Howard Regional Health System would like to amend its Byproduct Materials License, Number 13-13028-02, to list Richard Stephens, M.D. as the Radiation Safety Officer. Dr. Stephens has previously served as the Radiation Safety Officer on the Blackford Community Hospital U.S.N.R.C. license, Number 13-20449-01 (license terminated 2005). We ask that the currently listed R.S.O. on our license, Dr. Dada, be retained on the license as an Authorized User.

Finally, please find enclosed an updated facility diagram of the nuclear cardiology department. The updated diagram reflects the true direction of north, which was mislabeled on the facility diagram previously submitted.

CVL STRESS TESTING ROOM 1
LOCATED IN THE BASEMENT IN THE
CARDIOVASCULAR DEPARTMENT
HOWARD REGIONAL HEALTH SYSTEM

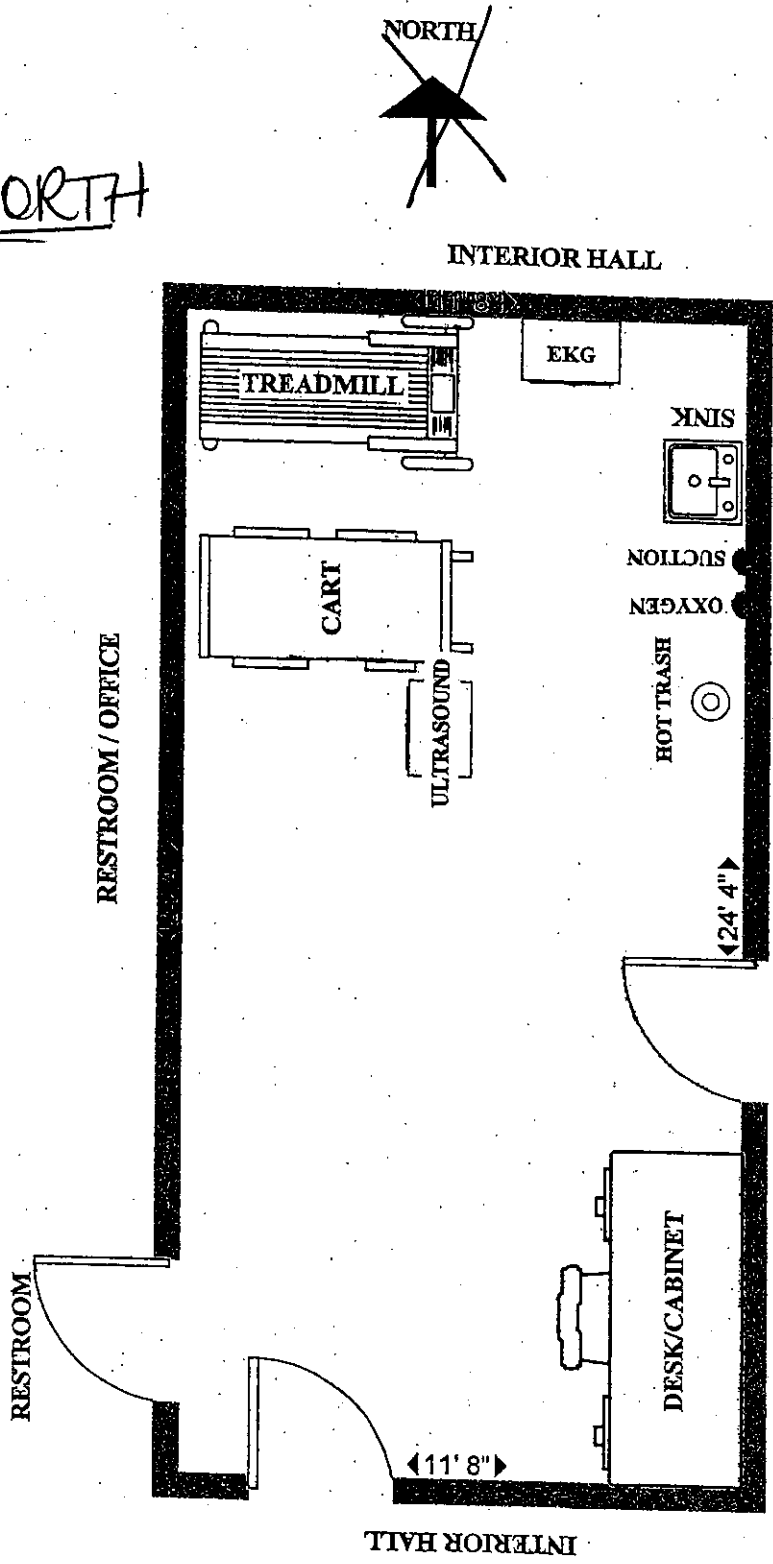
"North" direction corrected on 3/18/06 - will change on next amendment

CVL TESTING ROOM 7
LOCATED IN THE BASEMENT IN THE
CARDIOVASCULAR DEPARTMENT
HOWARD REGIONAL HEALTH SYSTEM

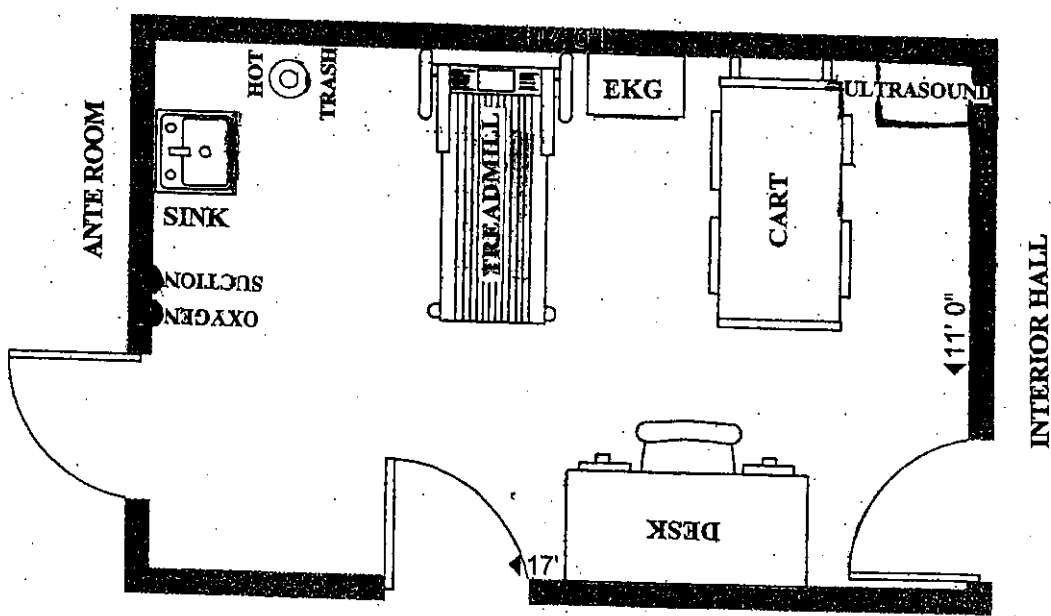
"North" direction corrected on 3/18/06 - will change on next amendment.
